Access Compliance Report

Public Rights-of-Way (Curb Ramps)

Intersection ID: 10038573	Main Street: SPRINGMAN_LN	Cross Street: N/A	Location:	E
ADA ID: F7A029DA767E	Ramp Type: BlendTrans1	Initial Pass/Fail: Fail	Overall Compliance: No	Severity Score: 10

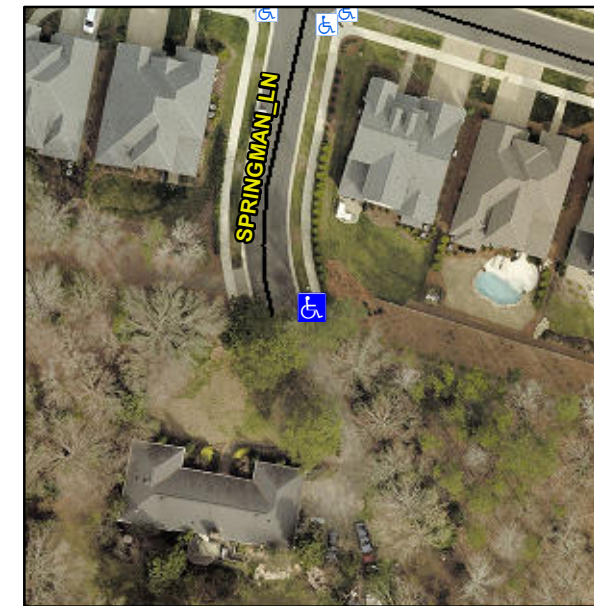
Not Found, R304.5.1

Compliance	Description	Data	Compliance	Description	Data
N/A	Ramp Length (in)	27.5	Yes	BlendTrans Slope (%)	2.7
No	Ramp Width (in)	47.0	Yes	BlendTrans XSlope (%)	3.9
N/A	Flare Type LT	N/A	N/A	Flare Type RT	N/A
N/A	Flare Slope LT (%)	N/A	N/A	Flare Slope RT (%)	N/A
N/A	Flare Traversable LT?	N/A	N/A	Flare Traversable RT?	N/A
N/A	Landing Length (in)	N/A	N/A	DWS Provided?	N/A
N/A	Landing Width (in)	N/A	N/A	DWS Contrast?	N/A
N/A	Landing Slope (%)	N/A	N/A	DWS Length (in)	N/A
N/A	Landing X Slope (%)	N/A	N/A	DWS Full Width?	N/A
N/A	Landing Curb? (Y/N)	N/A	N/A	DWS Offset (in)	N/A
N/A	Shared Landing?	N/A			
N/A	Gutter Ponding?	N/A	N/A	Gutter Slope (%)	N/A
N/A	Gutter Lip Ht (in)	N/A	N/A	Gutter X Slope (%)	N/A
N/A	Painted X Walk1?	No	N/A	Painted X Walk2?	N/A
	X Walk 1 Direction	To W		X Walk 2 Direction	N/A
	X Walk 1 Width (in)	N/A		X Walk 2 Width (in)	N/A
	X Walk 1 Slope (%)	0.8		X Walk 2 Slope (%)	N/A
	X Walk 1 X Slope (%)	6.2		X Walk 2 X Slope (%)	N/A

N/A	Ramp inside XWalk1?	N/A	N/A	Ramp inside XWalk2?	N/A
	Road Slope (%)	6.2		Clear Space?	N/A
	Road X Slope (%)	0.8	N/A	Clear Space to XWalk (in)	N/A
N/A	Any Obstructions?	N/A	N/A	Storm Grate/Utility Hazard?	N/A
	Obstruction Type			Storm Grate/Utility Type	
		N/A			N/A
			Yes	Surface Condition? (G/P)	Good
			No	Curb Slope (%)	9.2

Remove & Replace Curb Ramp With Two New Directional Ramps or Equivalent.
